U-ESR-H-00128

**Tank 16 – Response To NRC Comments  
On Closure Module**

The United States Nuclear Regulatory Commission (NRC) provided comments to South Carolina Department of Health and Environmental Control (SCDHEC) on *Industrial Wastewater Closure Module for Liquid Waste Tank 16H H-Area Tank Farm Savannah River Site*, SRR-CWDA-2013-00091, during the SCDHEC public comment period. Several of the comments are associated with final residual volume estimates for the Tank 16 annulus. As discussed in Section 3.2.1 of the Closure Module, the residual waste volume has been estimated on three occasions in the recent past (i.e., 2007, 2012, and 2013). In the revised estimates, the annulus volume decreased from 4,760 gallons to 3,300 gallons to 1,910 gallons although no additional waste removal had occurred. The decrease in the estimated volume was not unexpected considering subsequent volume estimates apply additional rigor which is intended to remove uncertainty. Since the volume estimates are typically biased high in cases when few relative landmarks are present (such as the Tank 16 annulus), removing uncertainty would reasonably result in volume decreases.

Figure 1: Tank 16 orientation and sample locations

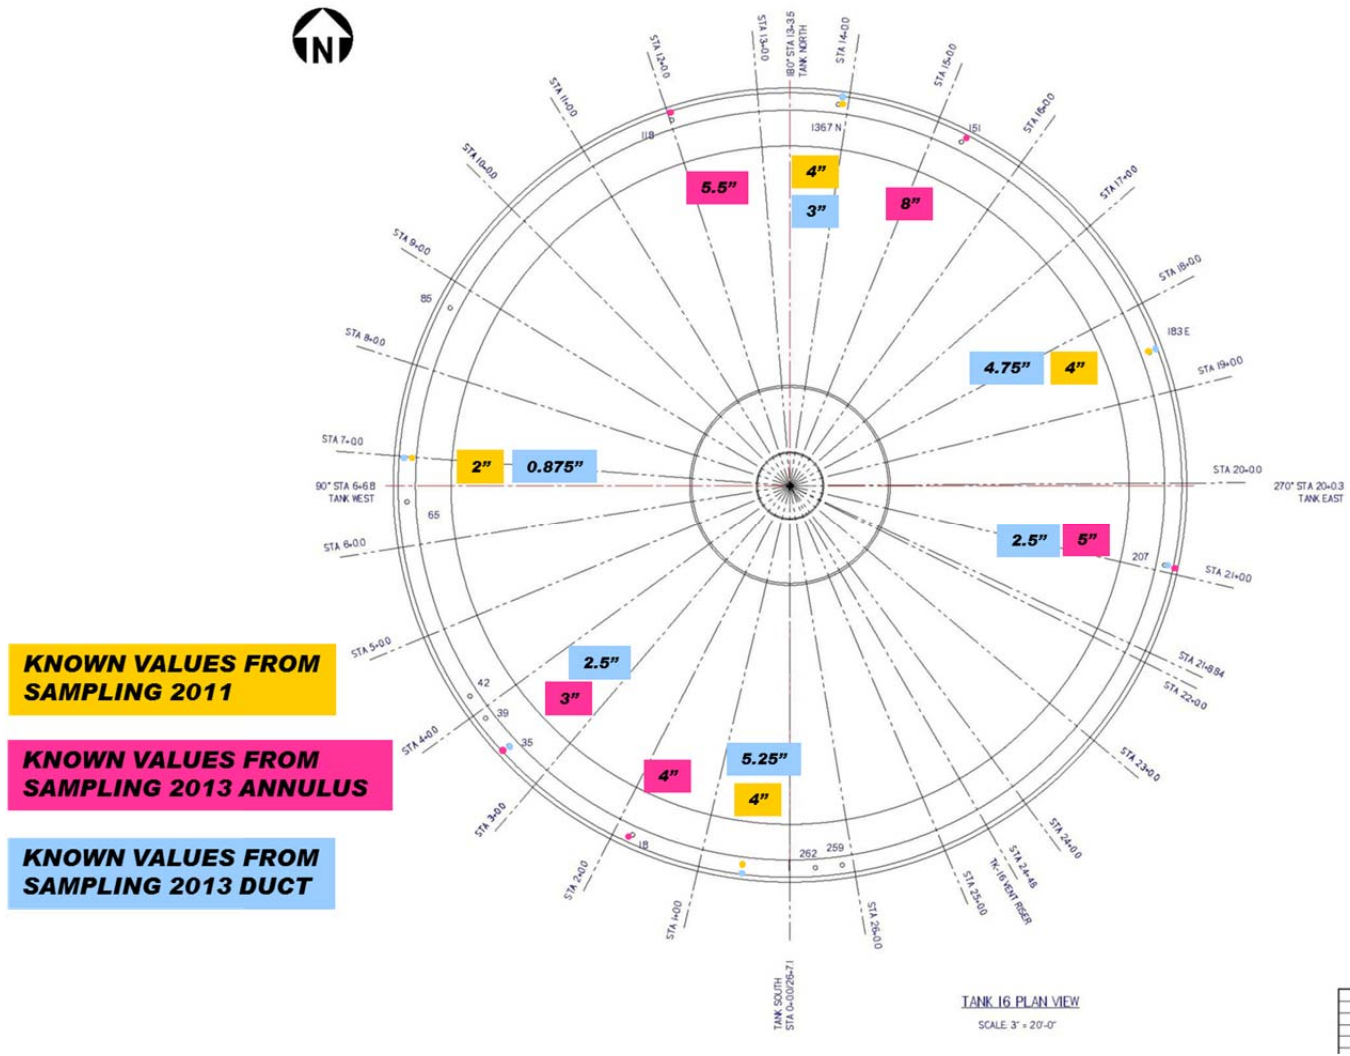
“Based on NRC staff’s detailed review of the Closure Module and associated references, documentation could be more transparent on how the revised volume was determined. NRC staff offers several detailed comments related to (1) the sampling method used to determine material heights, (2) the use of photographic evidence and landmarks to assign material heights, and (3) interpolation method used to assign material heights in areas where no sample or visual observation are available.”

Figure 1 provides orientation (station locations, sample locations, and photograph locations) around that Tank 16 annulus to support the individual comment responses in this document.

Figure 5: (Area at STA 8+00 interpolated to a height of 2 inches in 2013. Photo L U-ESR-H-00113)

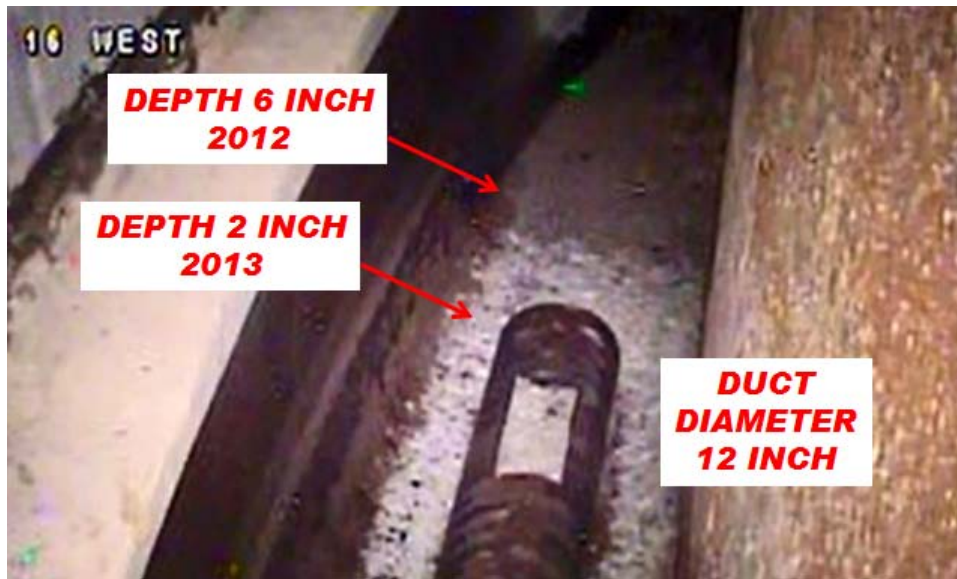
Photographs of STA 8+00 below show an area that was revised from 6 inch height in the 2012 volume estimate to 2 inch height in the 2013 volume estimate. The photograph from 2012 was

used to assign a height of 6 inches to this area (Figure 4) from visual observation. Based on photographs available at the time, this value would have been higher in 2012 if not for the measured sample height of 2 inches in the vicinity. This value was believed to be an accurate representation of the area based on both visual observation and measurement data. Photo L from U-ESR-H-00113 displays the area in more detail from 2013 (Figure 5). The measured sample height of 2 inches was interpolated across STA 8+00 due to the appearance of minimal material in the newer photos. Note the improved quality of the photograph in 2013 compared to the 2012 photograph.

Figure 6: (Area at STA 1+80 measured at 4 inches. Photo E U-ESR-H-00113)

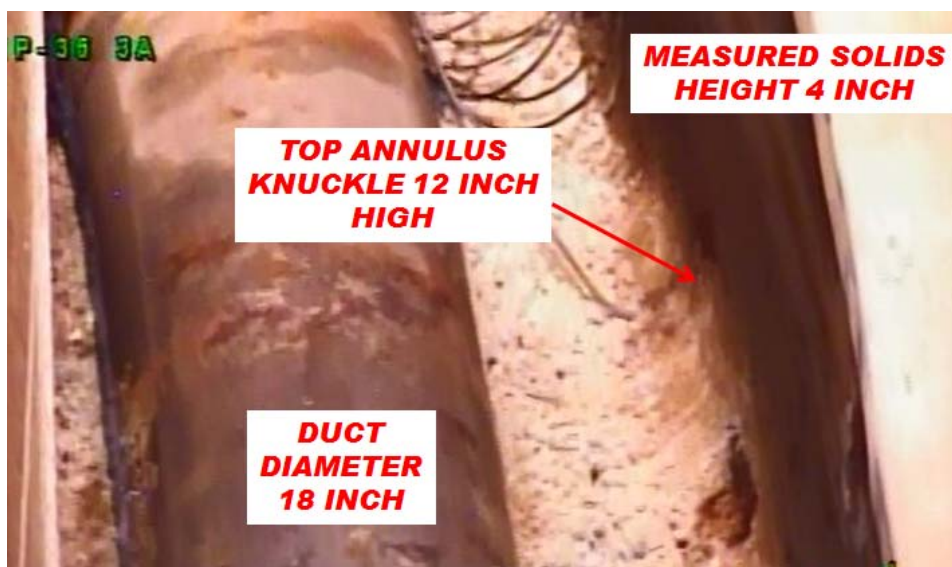
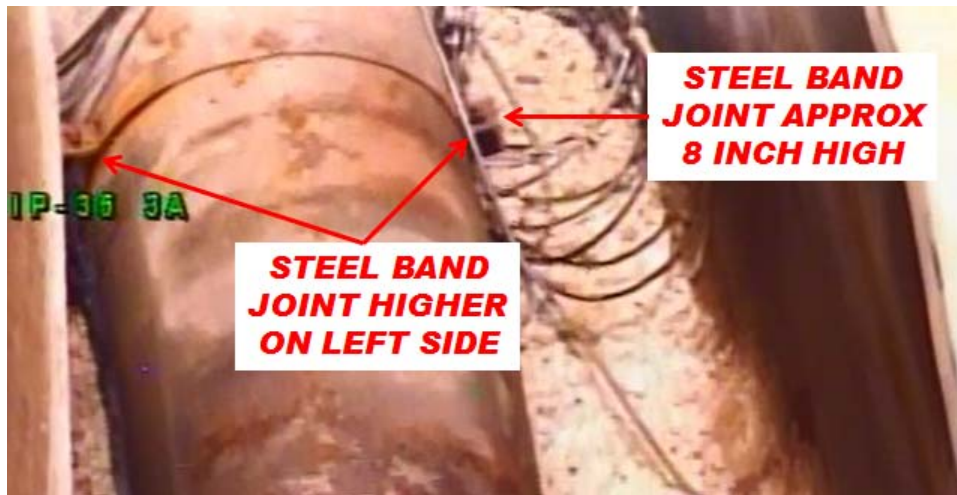
In general, the potential discrepancies between the measurements and what is observed in the photos using the landmarks could be better addressed. For example, it would be helpful if the photographs from similar locations from both 2011 and 2013 could be analyzed side by side, with the landmarks and depth assumptions clearly labeled. Information available from the measured samples could be discussed in terms of how it relates to the landmarks in each of the photos with any ambiguous or conflicting observations explained. Could DOE explain the visual evidence that supports the reduction in height for waste outside the duct near Stations 2, 3, 8, and 10?

The measured height at STA 1+80 was 4 inches in 2013. This is consistent with the measured value at South Riser STA 0+00 in 2012. A photo of the area in question is provided below (Figure 6). There are no landmarks in the area that are close to being 4 inches tall. The annulus knuckle has a 12 inch radius and the duct steel band joint is approximately 8 inches off the floor. Note that the steel band joint appears higher on the left side (Figure 7). If the steel band was configured with the joint horizontal, the level of the joint would be 10.4 inches. The solids layer in this area is below all available landmarks. There is no evidence to suggest that 4 inches is not an accurate depth for this area.

Figure 10: (Area at STA 10+00 interpolated to a height of 3 inches. Photo M U-ESR-H-00113)

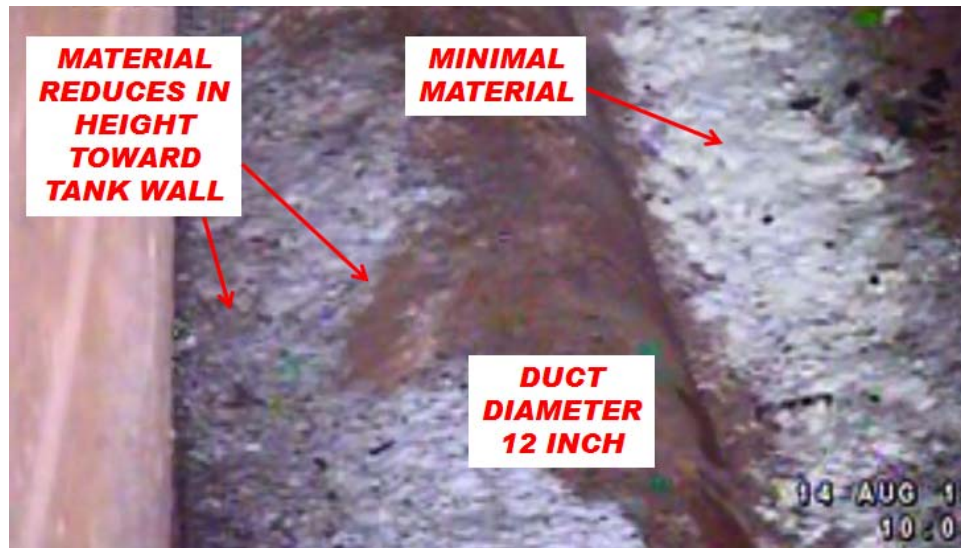
Could DOE describe the visual landmarks used in Photo M to support the height assumption at that location? Or, if instead, the height of the annulus waste near Station 10 is based on interpolation between nearby sampling locations, could DOE describe why the photographs near this Station were not used?

STA 10+00 is an area between two measured values of 2 inches and 5.5 inches. Visual evidence suggests that the solids height did not increase between the two sample locations, therefore the value at STA 10+00 would be 5 inches or less. There is a minimal amount of material to the right of the duct, material is coating the left side of the duct, then the material appears to decrease in height away from the duct to the left (Figure 10). Several data points were used to assign a value:

The interpolated height from the nearest measured heights (3 inches) was assigned for this area, and evaluation of visual evidence did not result in adjustment to the interpolated height. Visual depth perception was a factor in the decision to not adjust the interpolated height. A photo of the area is included below (Figure 10).

As stated in our methodology, an interpolation between measured sample heights was used in conjunction with visual observation to assign a height to the material in this area. STA 10+00 is an area between two measured values of 2 inches and 5.5 inches. Visual evidence suggests that the solids height did not increase between the two sample locations, therefore the value at STA 10+00 would be 5 inches or less. There is a minimal amount of material to the right side of the duct, material is coating the left side of the duct, then the material appears to decrease in height away from the duct to the left (Figure 10). Several data points were used to assign a value:

The interpolated height from the nearest measured heights (3 inches) was assigned for this area, and evaluation of visual evidence did not result in adjustment to the interpolated height. Visual depth perception was a factor in the decision to not adjust the interpolated height.

Figure 13: Portable Drill Rig

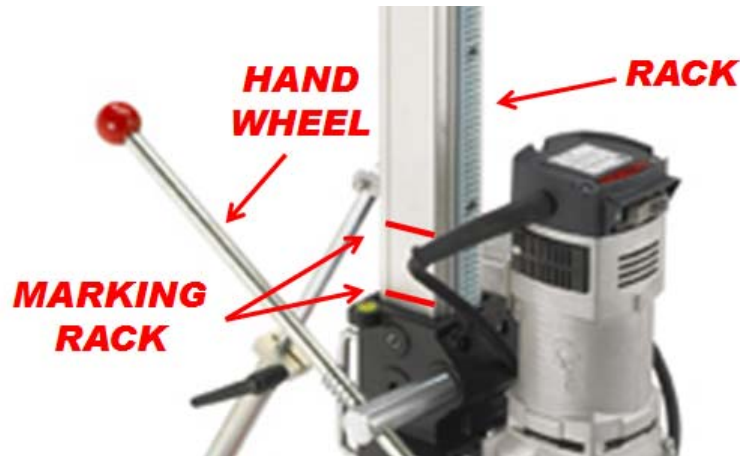
- a. Is reaching the top of the waste based on visual observation, or some other indicator?
- b. How variable are the waste height measurements due to surface roughness? If the surface of the waste is rough or variable along the radius, then there may be significant uncertainty in the height measurement in roughly the same measurement location.

The drill rig used is similar to the one pictured below (Figures 13 and 14). Vertical moment is controlled by the handwheel. The gear on the handwheel interfaces with a rack on the vertical column to hold or adjust vertical position. Marking and measuring vertical position on the column is simple and accurate. Uncertainty in this measurement would be very low.

Figure 16: Material Accumulated on Annulus Knuckle

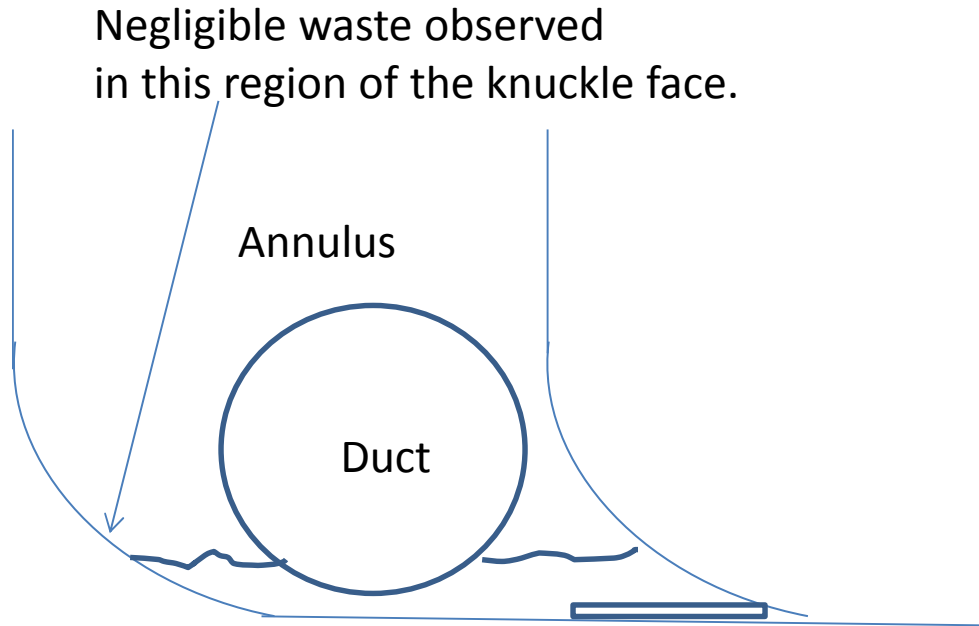
- c. How variable are the waste heights based on distance from the annulus wall or duct (i.e., does waste tend to accumulate on vertical surfaces)?
- d. It is not clear how one would determine when the top of the waste is reached in a duct where the duct itself is obstructing the view? How would one know when the auger reaches the top of waste in a duct in cases where a hole needs to be cut into the duct to sample (e.g., photograph H in SRR-LWE-2014-00151)?

Generally, solids were not observed accumulating on vertical surfaces (Figure 15). In some areas where solids height was minimal along the outside of the annulus, the level appears to conform to the curvature of the knuckle. Volumes estimated in these areas are determined according to the mapping team's judgement and experience. This was accounted for in the uncertainty values.

Figure 20: Annulus Duct Split

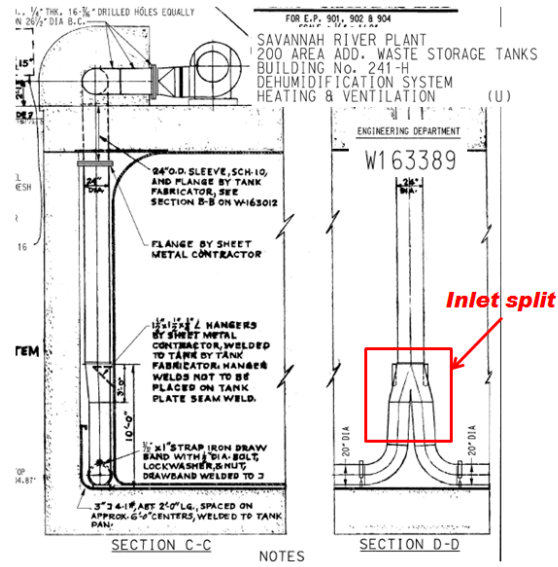
It is not clear how heights are determined for Tank 16H annulus waste located inside the duct between Stations 20.70 and 00.30 in the absence of sample measurements and photographs (SRR-LWE-2014-00151).

The documentation could better explain the extrapolation method used for areas lacking sample or photographic data (e.g., it does not appear to be a linear interpolation based on segment length). In looking at the depth assumptions listed in the spreadsheet in Figure A4-1: Tank 16H Annulus Residual Solids Chart of U-ESR-H-00113, it appears that the measured heights were entered at the various stations and an approximate interpolation between those measured heights was assumed. Also, as stated above in the comments regarding visual observation, it is unclear how the photo observations and landmarks helped inform the interpolated values.

The area between STA 20+70 and STA 0+00 is discussed in assumption 3.2.1.3 in U-ESR-H-00113:

- Annulus duct solids level is assumed to abruptly change at Station 22+00.  
**Justification:** This is the inlet of the annulus exhaust and the duct splits into two at an elevation well above the solids level on the floor. Therefore the two horizontal halves of the duct are not connected at this point. Since there is no visual evidence otherwise, it has been assumed that the solids level inside the duct on either side is similar to the level measured during sampling. This remains conservative as the highest observed levels on each side of the split duct are assumed and there is no reduction taken for the gap in the duct as it rises (see Figure 20, which is Figure 3.2-2 in U-ESR-H-00113).
